Model: Sh-P1	Date: 10-Aug-11	No.: RM020001a
--------------	-----------------	----------------

Subject: Firmware Release Note: Engine		Prepared by: K. Hamada	
From: 1st Overseas Tech Support Sec., 1st PQM Dept.			
Classification:	<input type="checkbox"/> Troubleshooting <input type="checkbox"/> Mechanical <input type="checkbox"/> Paper path <input type="checkbox"/> Product Safety	<input type="checkbox"/> Part information <input type="checkbox"/> Electrical <input type="checkbox"/> Transmit/receive <input checked="" type="checkbox"/> Other (Firmware)	<input type="checkbox"/> Action required <input type="checkbox"/> Service manual revision <input type="checkbox"/> Retrofit information <input checked="" type="checkbox"/> Tier 2

This RTB has been issued to announce the firmware release information for the **Engine**.

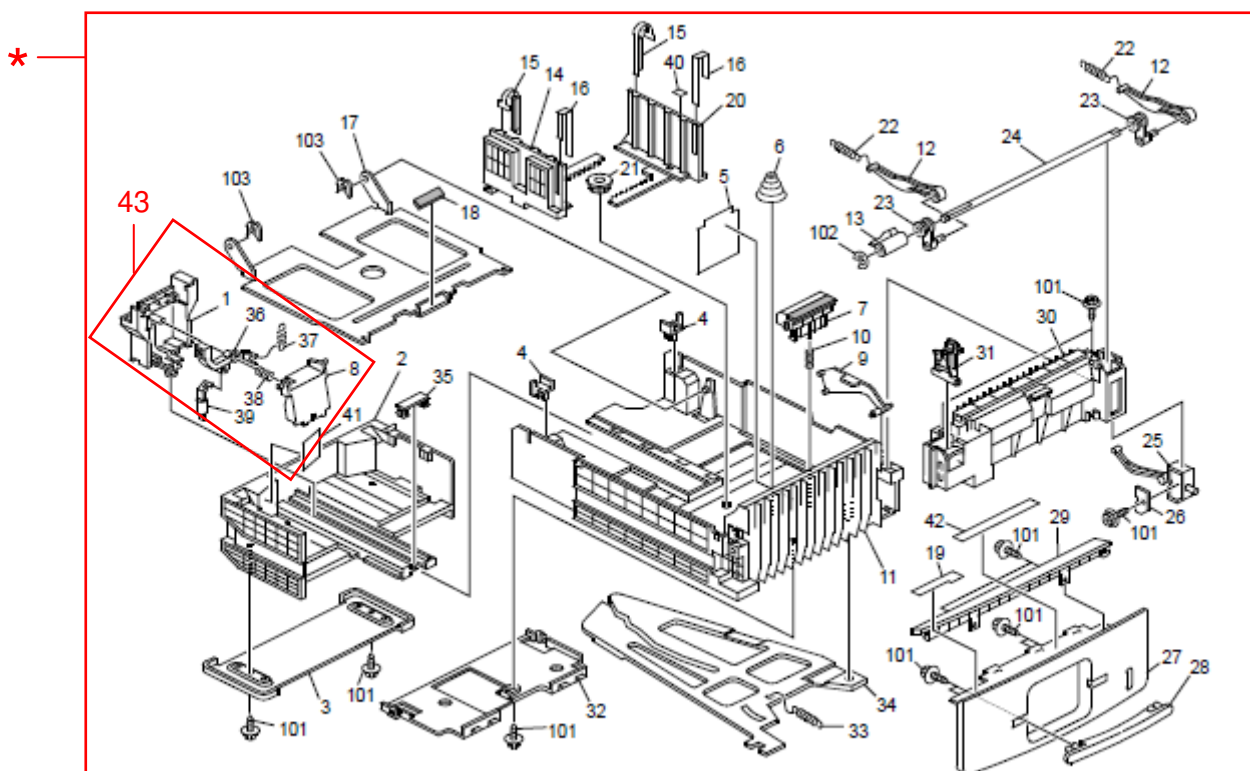
Change/Reason: The following parts number and index number were changed.

Incorrect part number	Correct part number	Description	Q'ty	Page	Index	Note
M0524200	M0524201	GUIDE:EXIT:FUSING	1	25	4	-

CAUSE

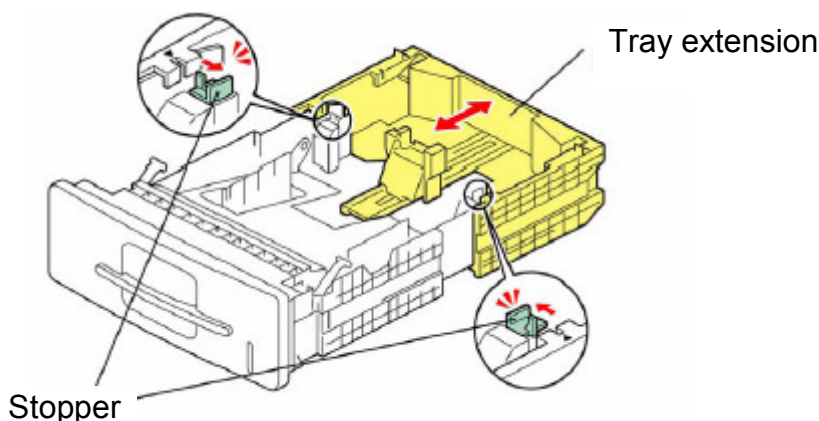
The stopper breaks and the tray extension extends out too far, causing the end fence to retract.

The shape of the stopper was changed, and four screw holes were added so that the extension tray can be fixed in place for LT/A4 and LG paper sizes.

4.Paper Tray (M020/M021)

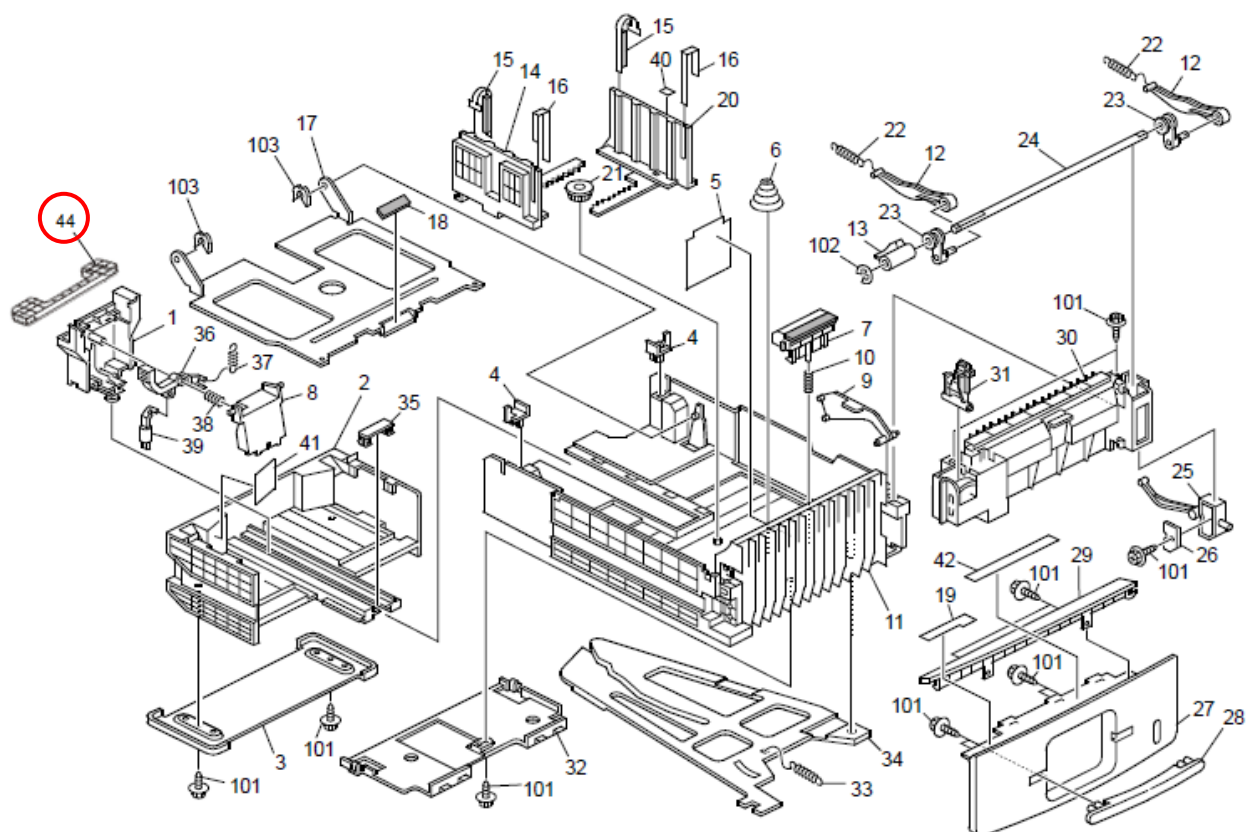
Change: A spacer was added.

Reason: To make sure that the operator sets the end fence in the correct position.

5.Paper Feed 1 (M020/M021)

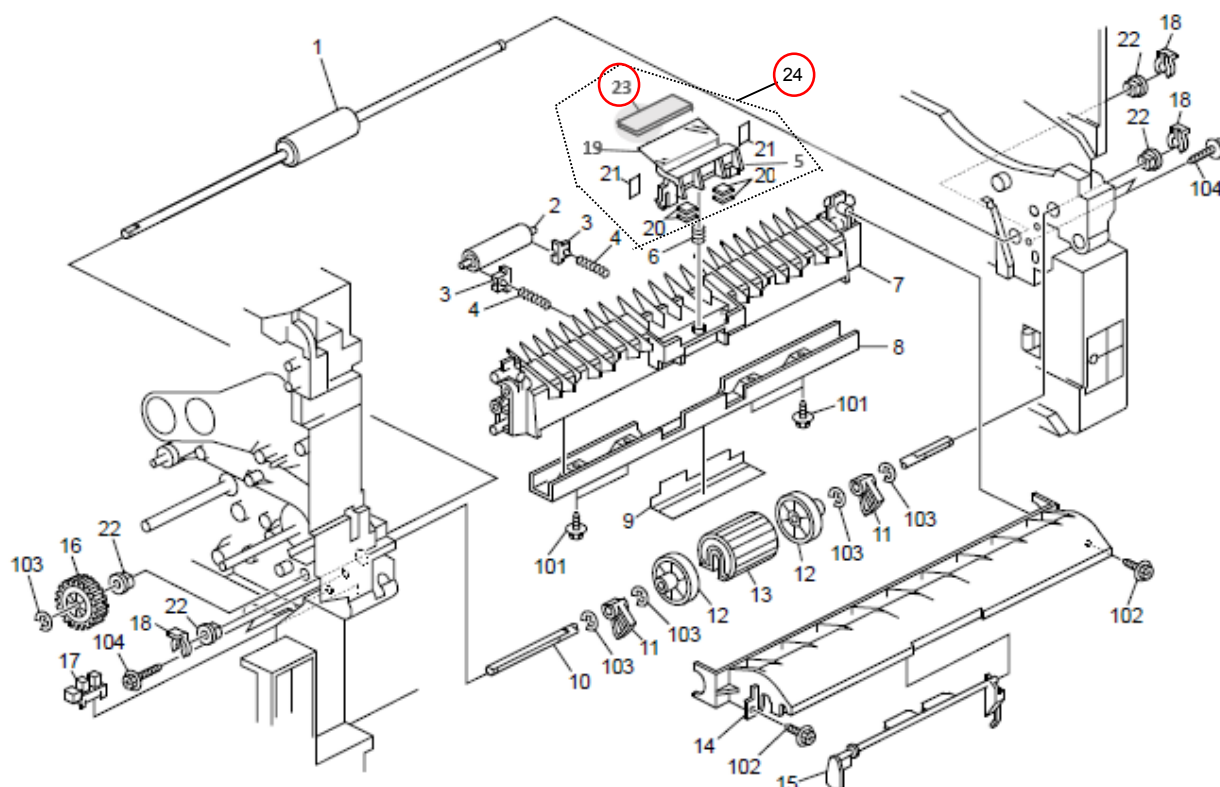
Old part number	New part number	Description	Q'ty	Int	Page	Index	Note
	G0963072	FRICITION PAD:8X50	1	-	15	23	
	M0522710	HOLDER:FRICITION PAD:MANUAL FEED:ASS'Y	1	-	15	24

10.Fusing Unit 1 (M020/M021)

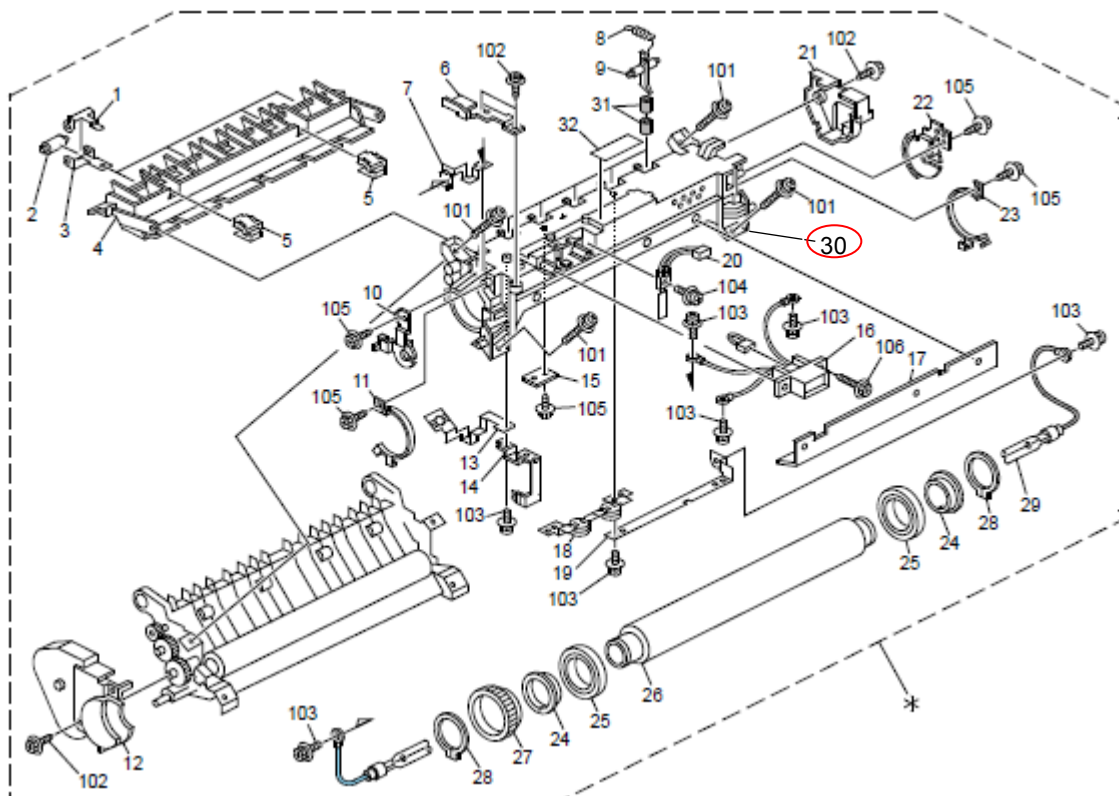
Change/Reason: Index #30 was added (it was missing from the illustration).

19.Controller Unit (M020/M021)

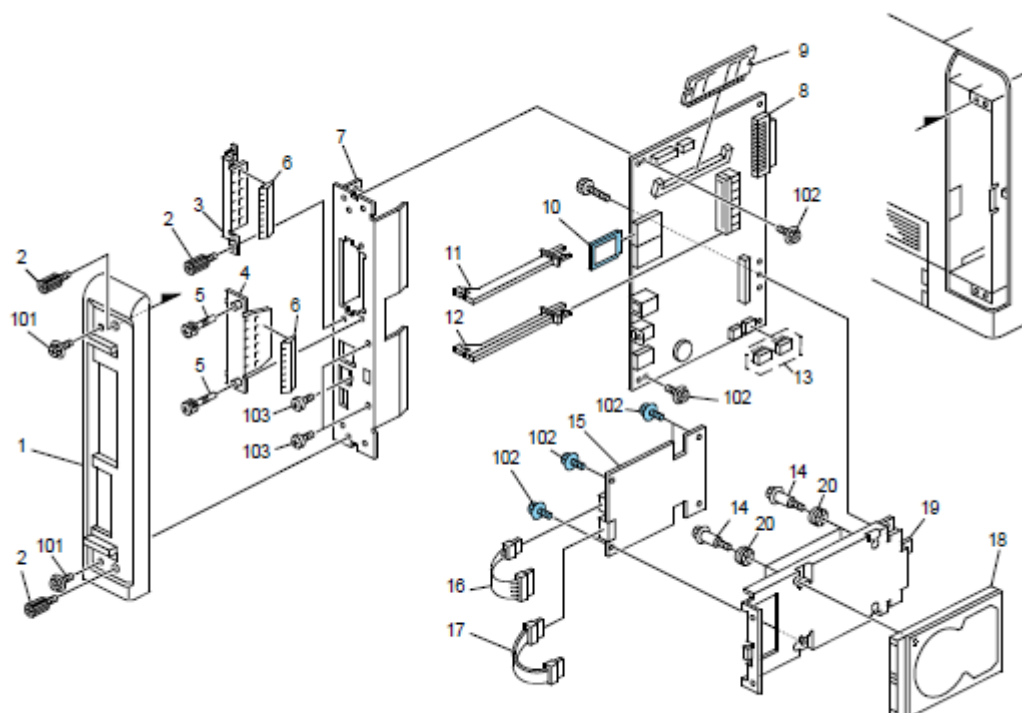
Change: The shape of the panel was changed.

Reason: To ensure that the SD card is not dropped between the panel and card cover.

16.Electrical Section 1 (M020/M021)

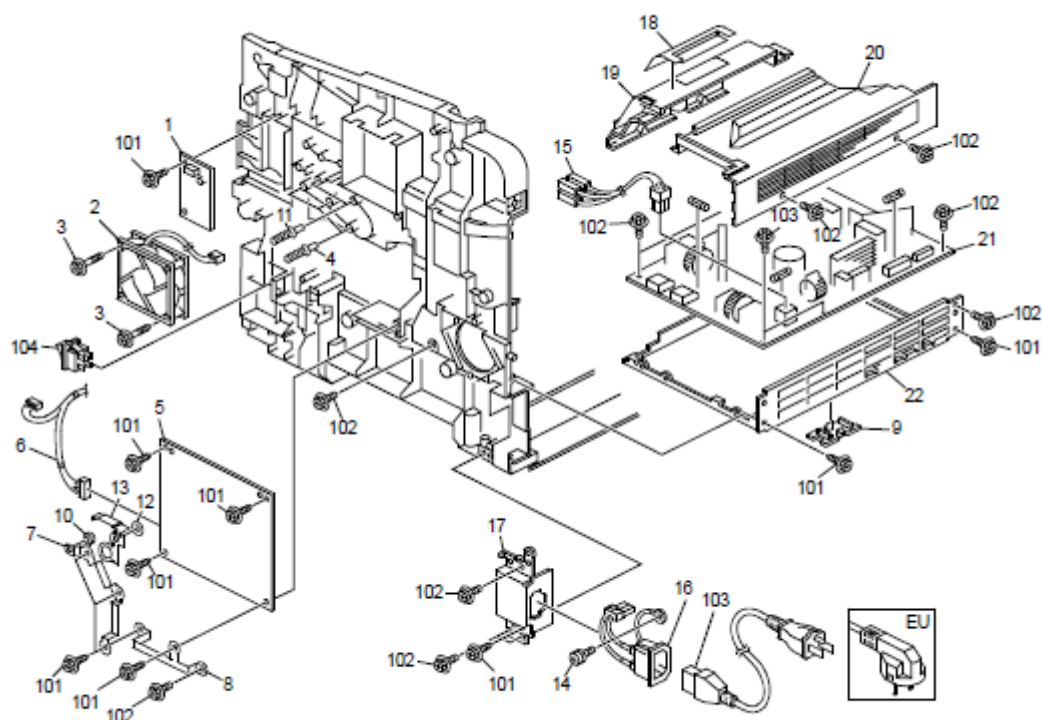
Change/Reason: The parts in the table had not been correctly registered in the system.

Note: A polishing countermeasure has been applied to these terminals.

16.Electrical Section 1 (M020/M021)

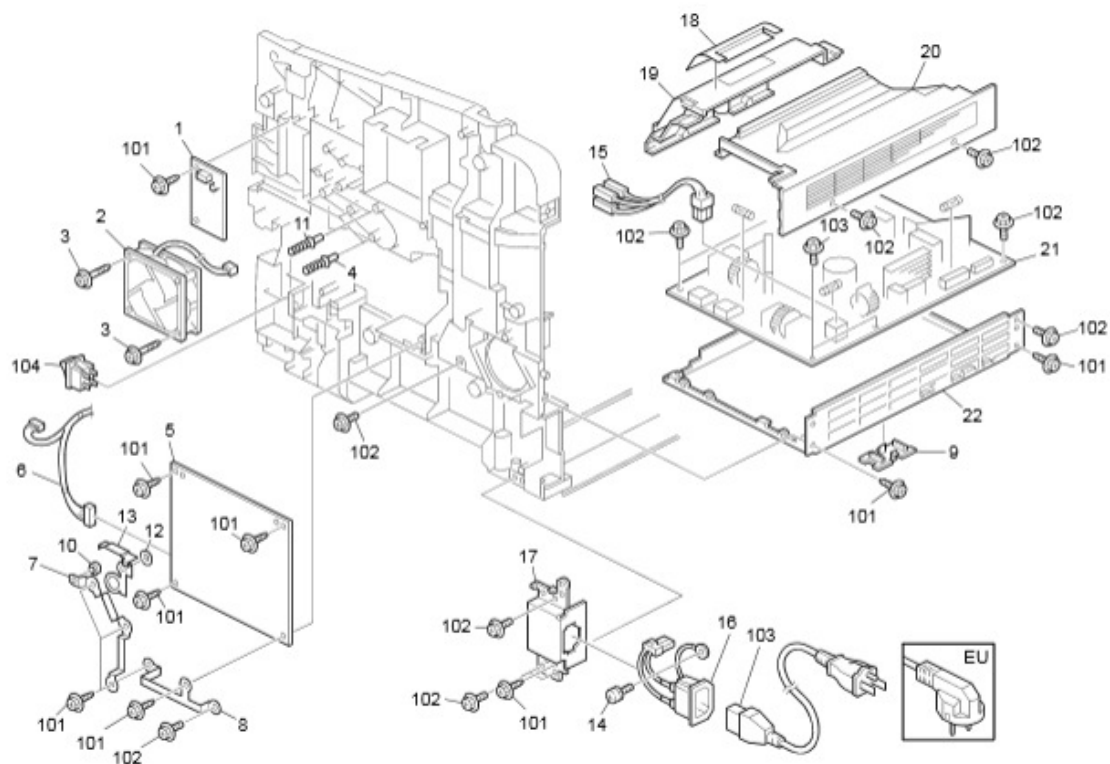
Old part number	New part number	Description	Q'ty	Int	Page	Index
M0522939	M0212939	GROUND PLATE:SUB:REGISTRATION ROLLER	1-1	× /O	37	7

1.Exterior 1 (M020/M021)

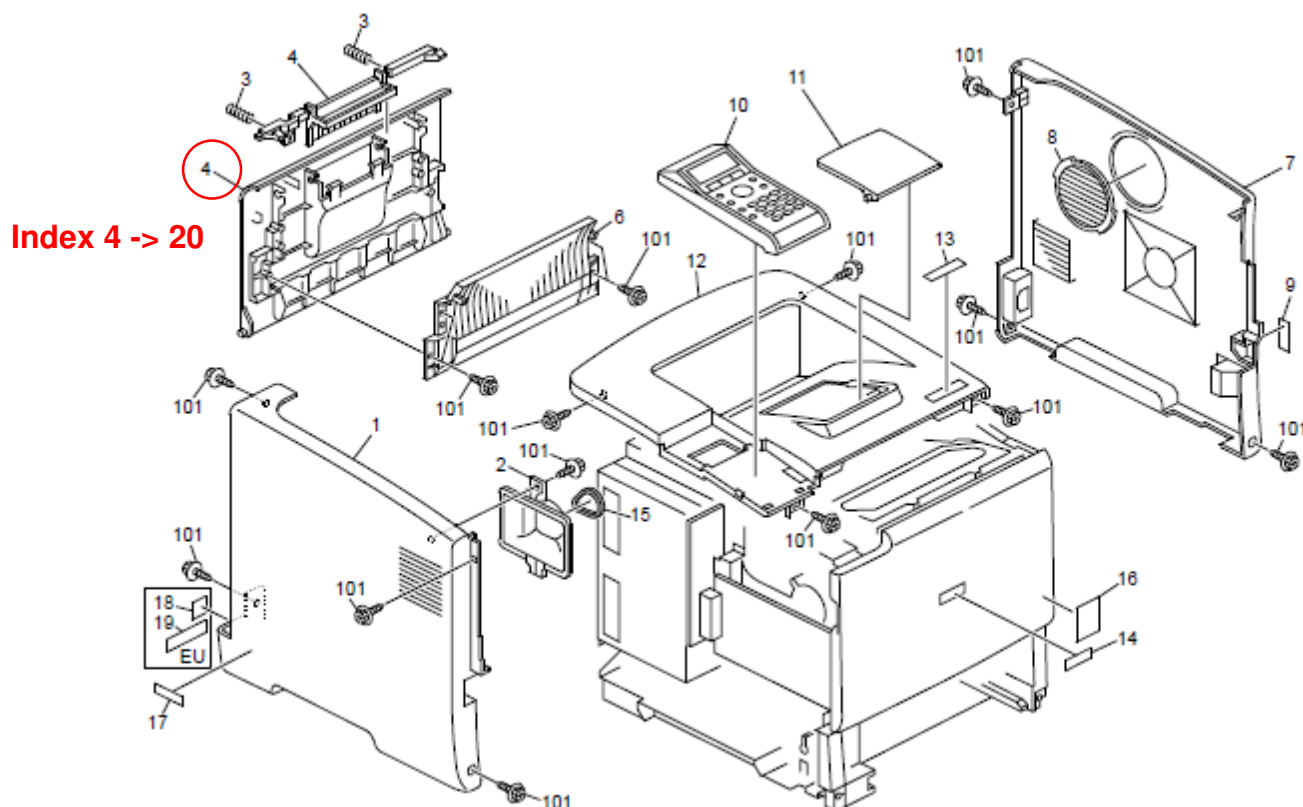
Change: None.

Reason: Index was duplicated.

7.Paper Regist (M020/M021)

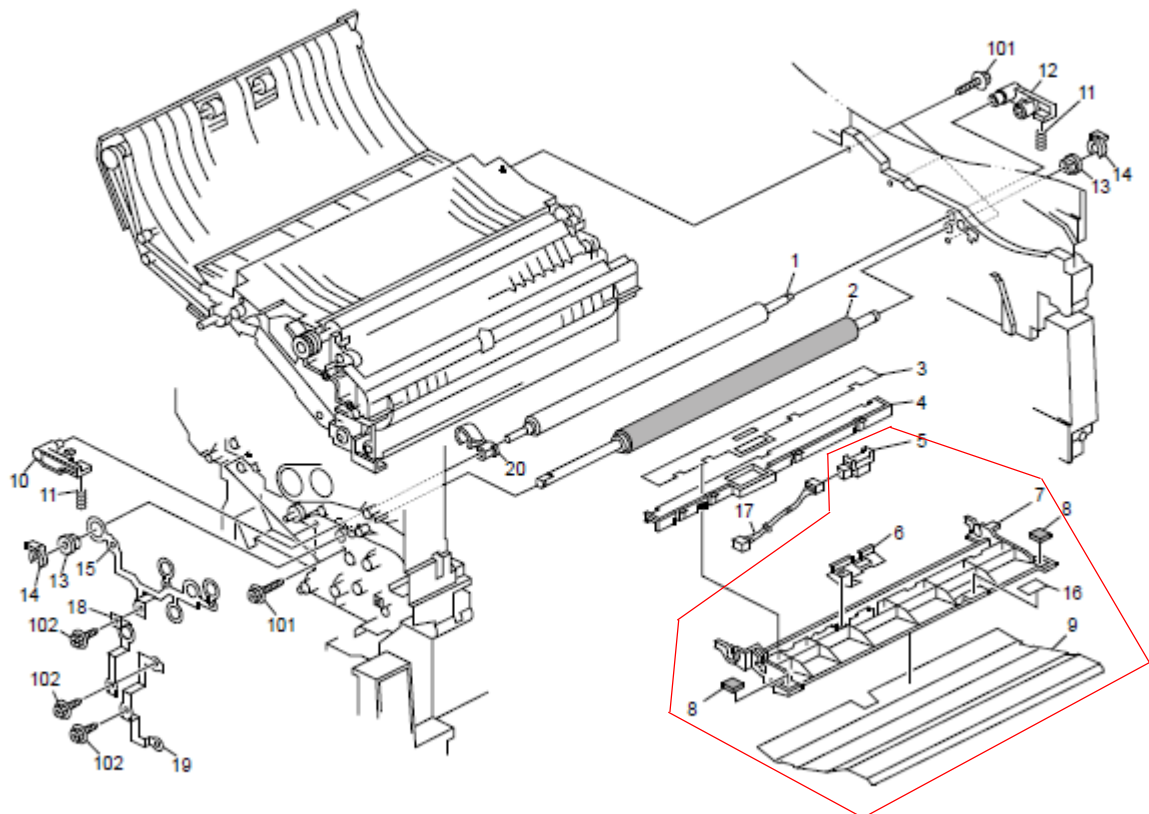
Old part number	New part number	Description	Q'ty	Int	Page	Index
-	M0522940	GUIDE PLATE:REGISTRATION:SUB:ASS'Y	0-1	-	18	21

Change: The assembly shown in the table was added as a service part.

2.Exterior 2 (M020/M021)

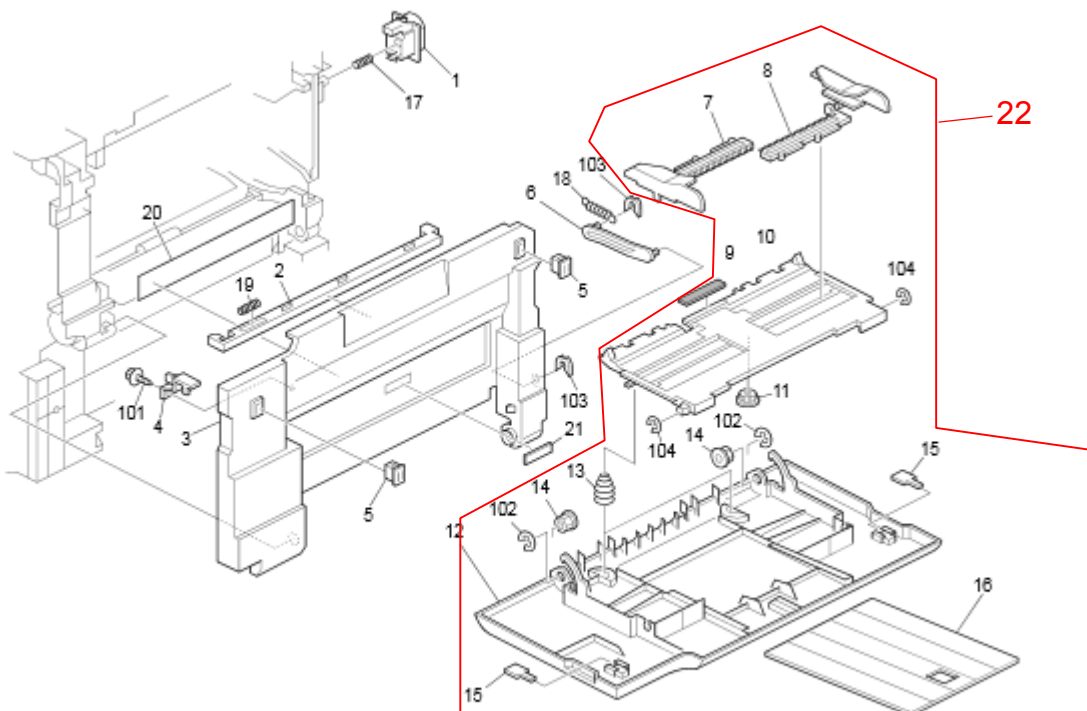
Old part number	New part number	Description	Q'ty	Int	Page	Index
-	M0212510	MANUAL FEED UNIT:P1	1	-	9	22

Change/Reason: The following part number and index number was changed.

1.Exterior 1 (M020/M021)

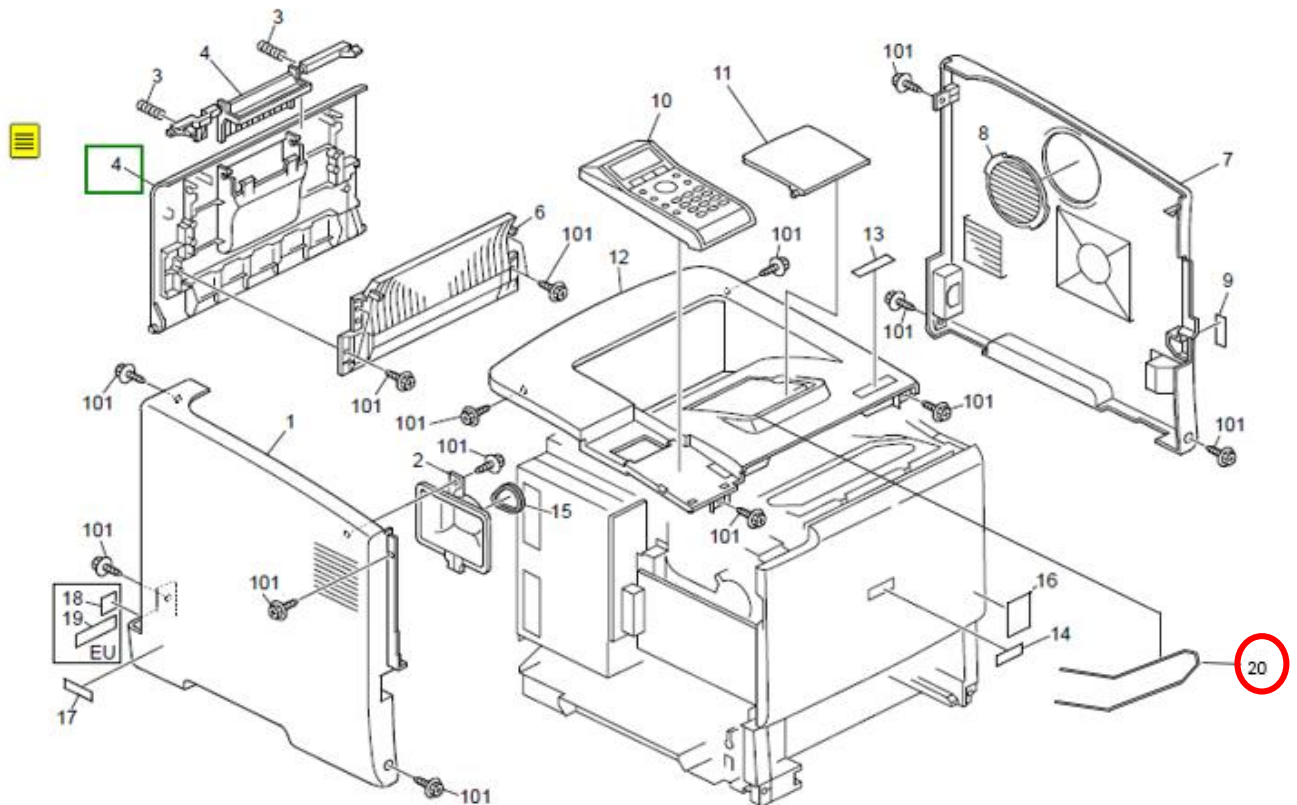
Change: The extension tray was registered as a service part.

Old part number	New part number	Description	Q'ty	Int	Page	Index	Note
-	M0211280	EXTENSION TRAY: BAIL: EXIT	0-1	-	7	20
